TOWN OF MIDDLEBURY

REGULAR MEETING MINUTES Tuesday, February 28, 2023 7:30 P.M.

At the request of the Town of Middlebury's Conservation Commission (a.k.a., Inland Wetlands & Watercourses Agency), REMA ECOLOGICAL SERVICES ("REMA") has been asked to review the plans and other supporting documentation for an application for activities within regulated wetlands and their upland review areas (URAs), for two proposed warehouse and distribution buildings, at the above-referenced +/-112-acre site. Our review is based on the following:

**Re: Response to Third Party Technical Wetland Application Review
Southford Park – Timex Site
555 Christian Road and 764 Southford Road
Middlebury, Connecticut
SLR: #141.20970.00002**

FIGURE 2: AREA B

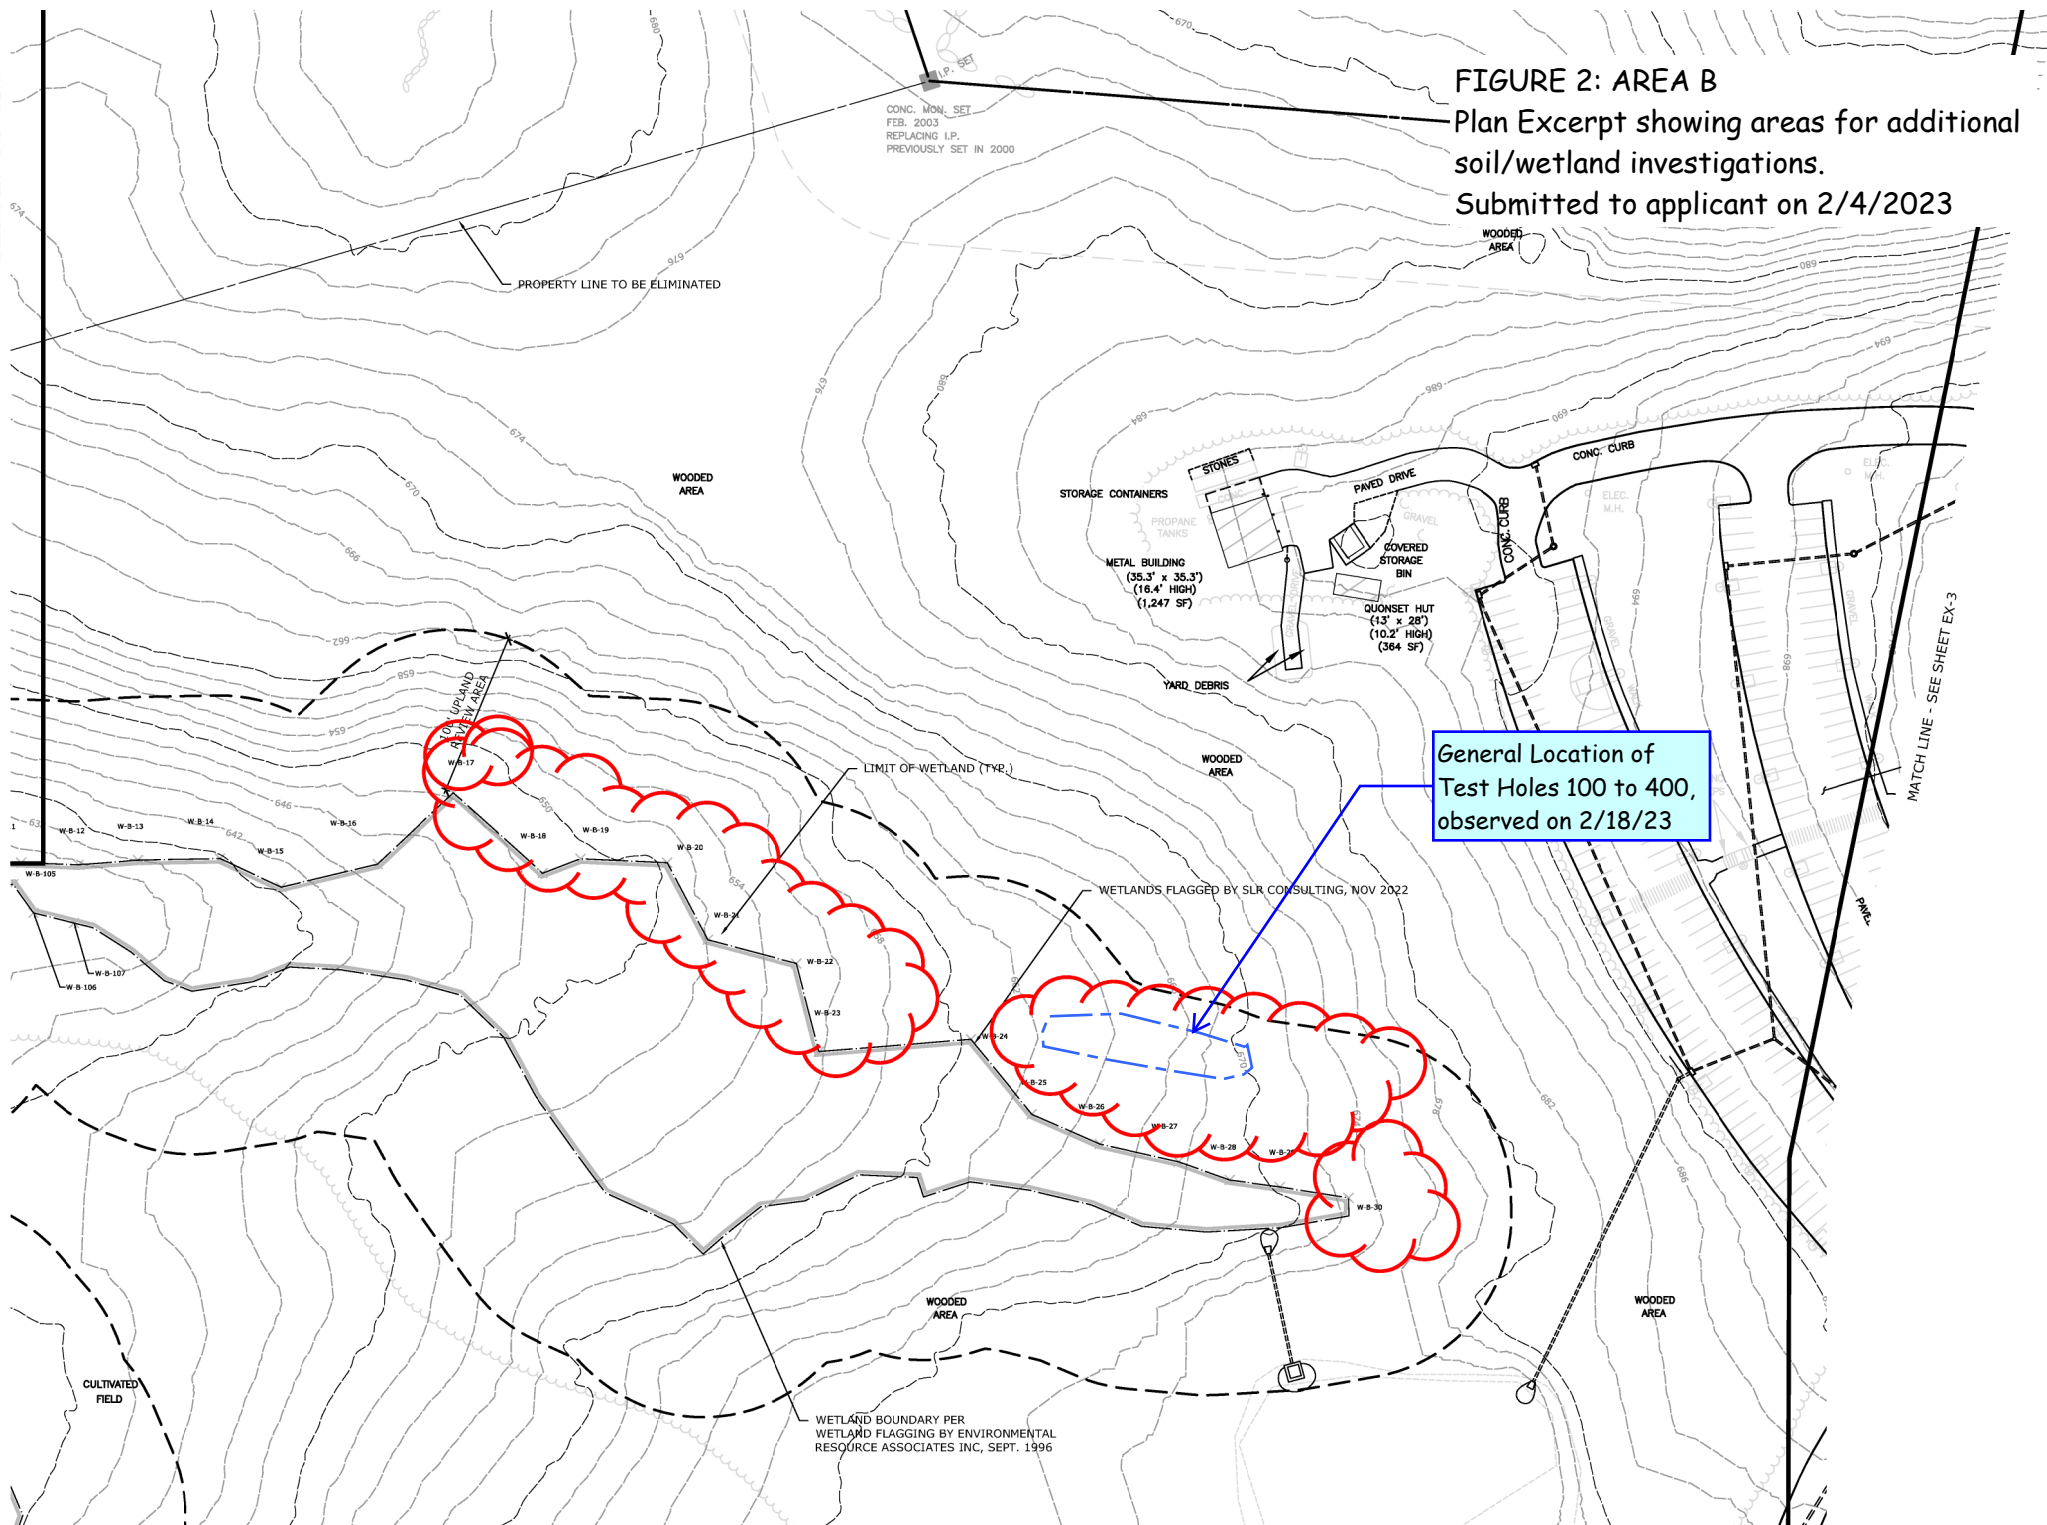
Overall, we found the wetland delineations to be substantially correct, as reviewed in the field. However, a few areas were observed where additional wetlands could occur, or where a delineated wetland boundary may have had to be revised. Also, the western wetland boundary of the southern portion of Federal Wetland A, above which the compensatory wetland mitigation is proposed, had not been recently delineated, so review was not possible at the time.

On February 18, 2023, REMA also re-visited one of the areas (i.e., Area B) depicted in Figure 2, that had been forwarded to SLR on February 4, 2018. As had been mentioned in our communication at that time, poorly drained profiles had been observed during the February 3, 2023, site visit. REMA developed and logged four additional test holes (i.e., Test Holes 100, 200, 300, and 400), within a linear shallow depressional area in the landscape, approximately 60 to 70 feet westerly of the delineated boundary for Federal Wetland B (see Figure A, attached). While these, more or less, equally spaced test holes, are representative, REMA is of the opinion that a wetland area, which may or may not connect to Federal Wetland B, exists at this location (also see attached annotated photo log).

The first location that was reassessed was located at the headwaters of an intermittent watercourse and forested seep wetland that ended in the field with Wetland Flag W-B-30. The area in question is located approximately 1 foot higher in elevation than wetland flag W-B-30 location, and the area is vegetated with red maple (*Acer rubrum*), shagbark hickory (*Carya ovata*), multiflora rose (*Rosa multiflora*), common spicebush (*Lindera benzoin*), and Japanese barberry (*Berberis thunbergii*). No active surface water flow, stained leaves, and/or ground water breakout were noted within this area. Three Dutch augur samples were completed within this area, and it was found that the soils had a 6-inch-thick A Horizon with a matrix color of 10YR 3/1 and a Bg horizon of 10YR 4/2. As such, SLR extended the wetland flags in this area and included a new location for W-B-30 and additional flags W-B-31 through W-B-34. This wetland boundary modification has been added to the plans.

FIG. 1

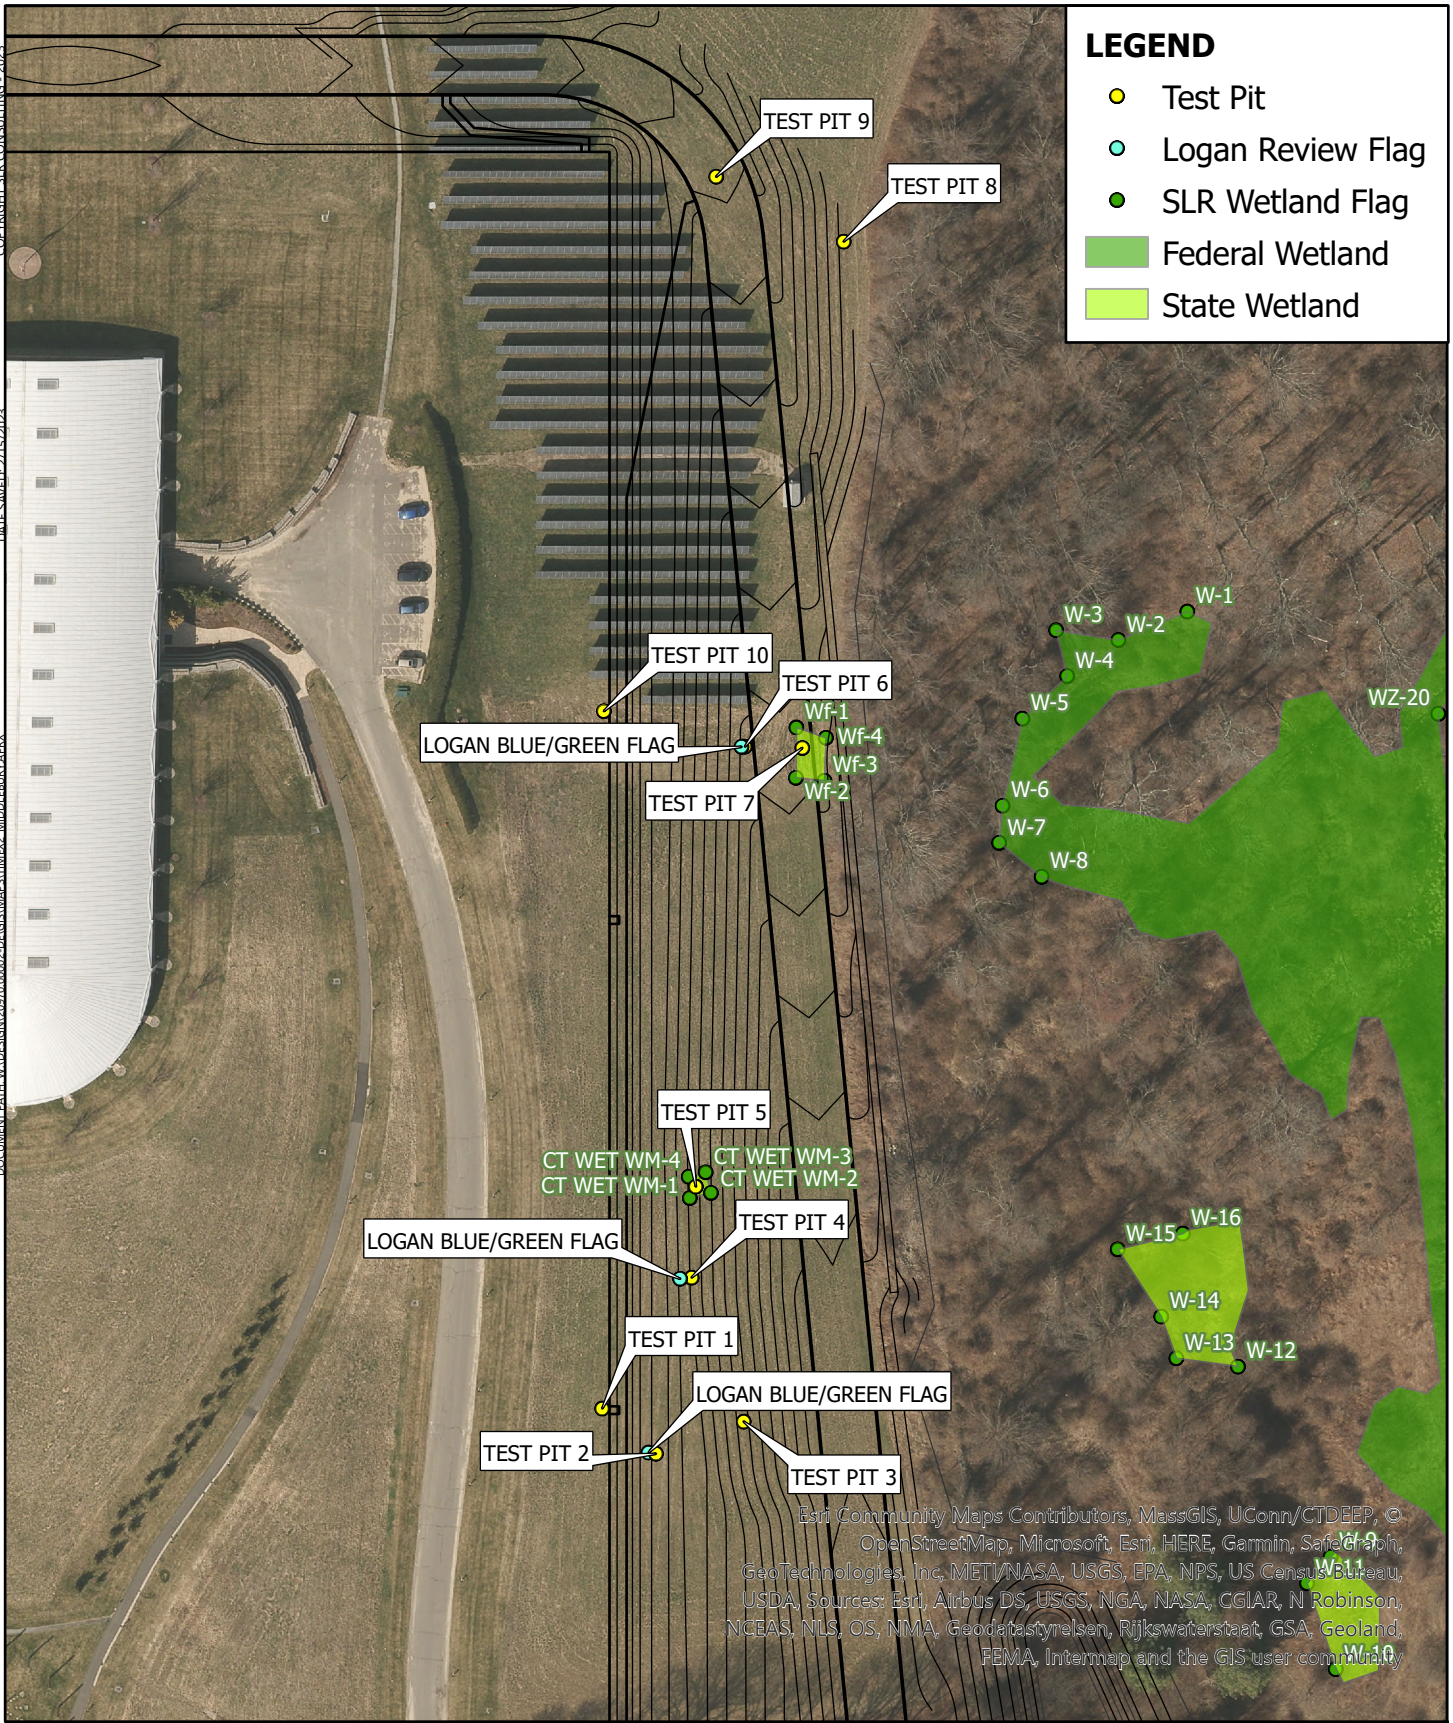
On February 18, 2023, REMA returned to the site, and to the same areas (i.e., Areas A, B, and C), to verify the data submitted by SLR. All of the SLR test pits in the existing mowed field to the east of the Timex building were left open for review. REMA reviewed most of the SLR test pits, but also further explored the soils and opened five additional test pits (i.e., Test Pits A through E). The photo logs and descriptions for these additional five soil test pits are attached.

three small clumps of soft rush (*Juncus effusus*) in one of the reed canary grass patches, which is a facultative wetland plant. There were four troughs that Mr. Logan identified on the mapping provided by email. As has been stated, Mr. Logan set blue and green flags within the troughs that he felt warranted further investigation of the soil drainage classification. Test pits were completed across the slope and in the areas flagged by Mr. Logan. Ten hand shovel/Dutch augur test pits were completed within the various troughs. These test pits are shown on the attached Figure 1 – Test Pit Locations. In addition to test pits, Dutch augur holes were completed in and around the areas in question for further confirmation of the observations being made within the test pits. The results of the test pits are presented on Table 1-1. A photo log of each of the test pit cores is appended.

Figure 2

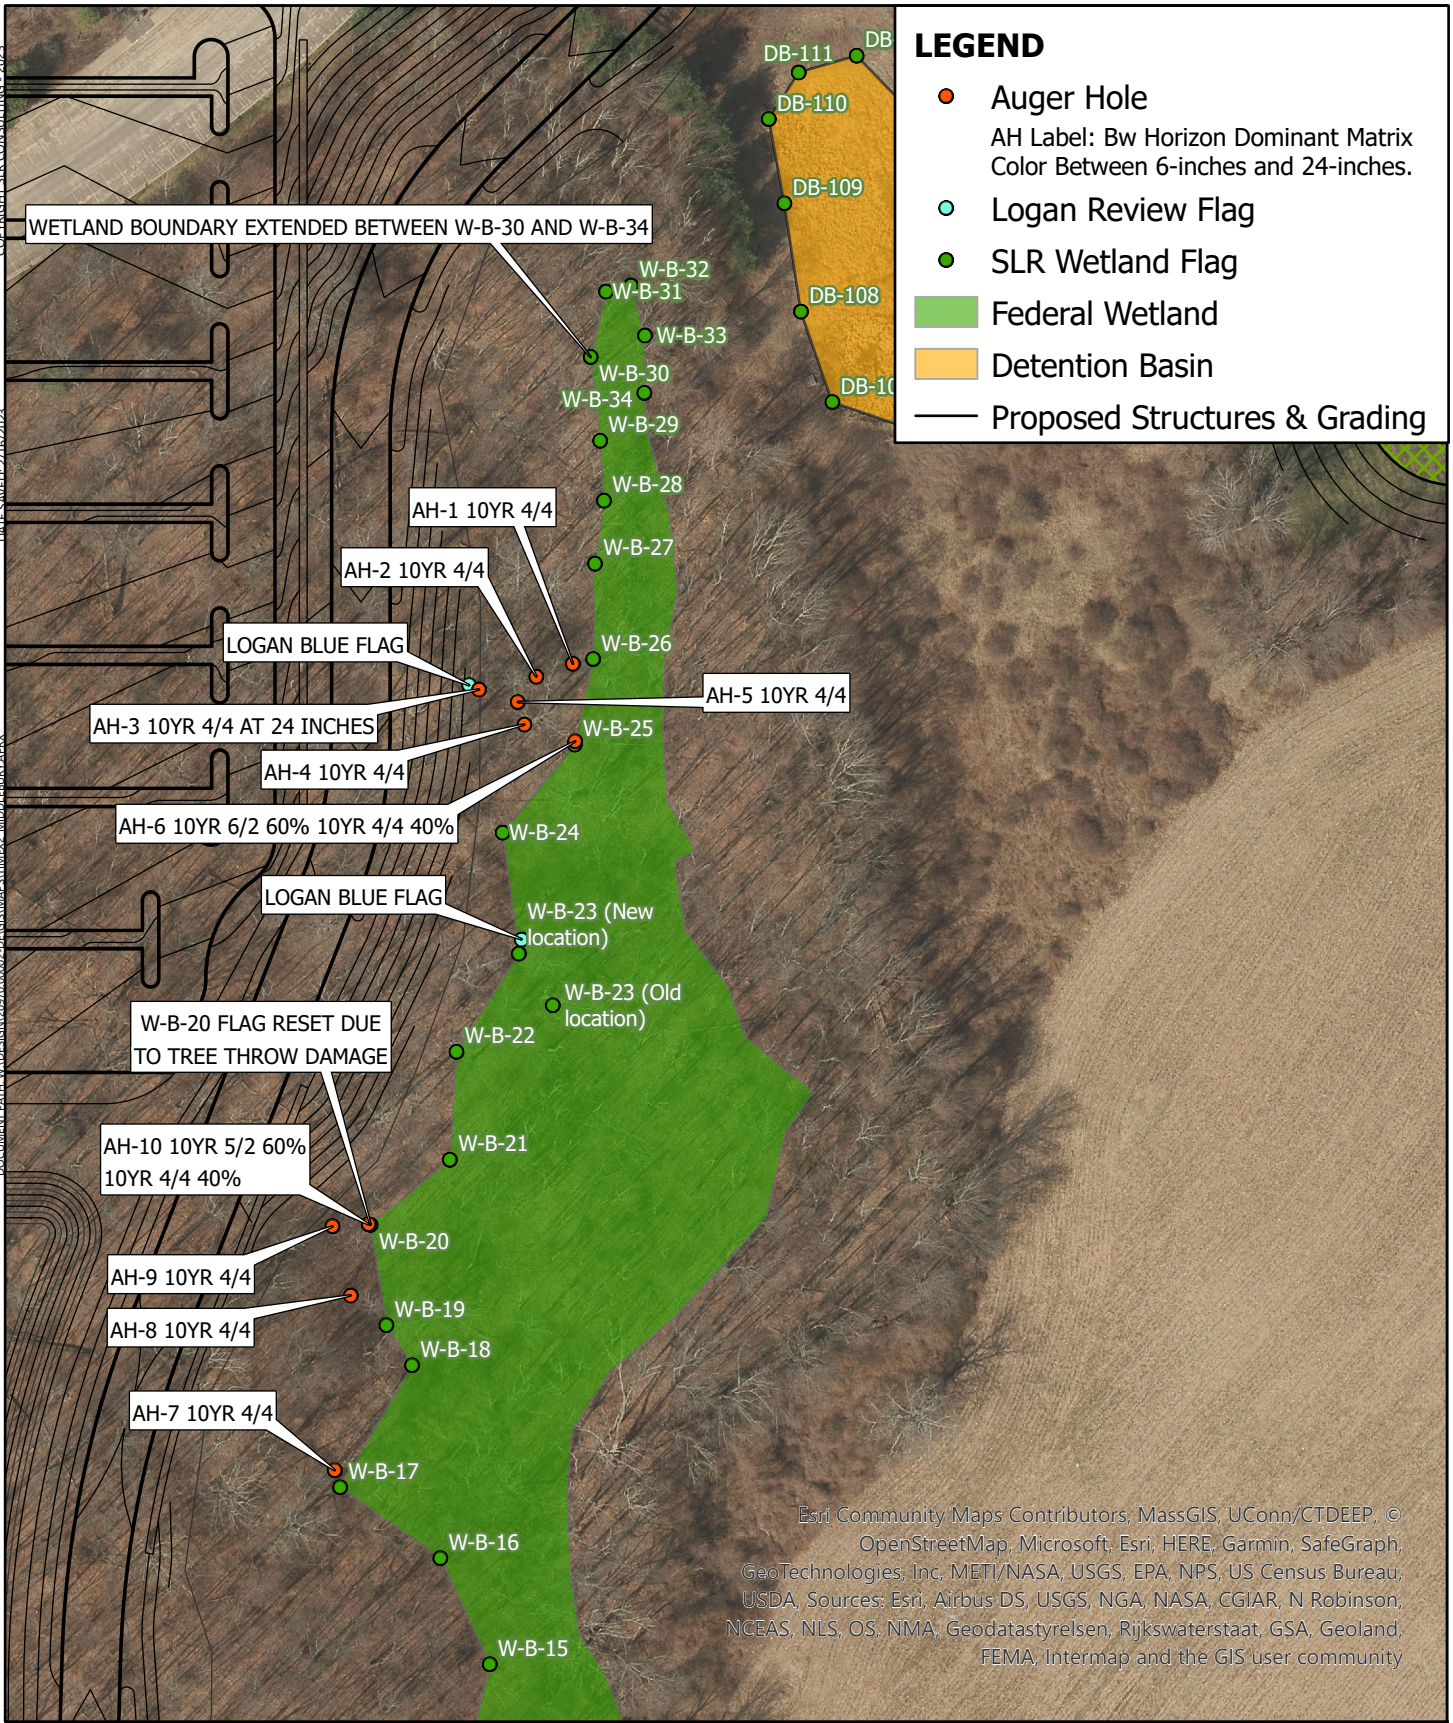
REMA also reviewed the adjustments to the wetland boundary at the “head” of Federal Wetland B, in the vicinity of re-hung wetland boundary markers W-B-30 to W-B-34. REMA would have extended the delineation to a single point, along an obvious through flow, roughly 20 feet upgradient, to the previously hung blue REMA flag (see Photo 12, attached). However, with the recent SLR adjustments REMA believes that this wetland delineation is substantially correct.

In addition to assessing additional areas in the mowed field, Mr. Logan requested additional assessment of four areas associated with Federal Wetland B, which is represented by the wetland flag sequence W-B-#. Mr. Logan affixed blue flagging in areas that he wanted SLR to review for potential expansion of the existing delineated wetland boundary. Figure 2 illustrates the soil core locations and map edits for this wetland area.
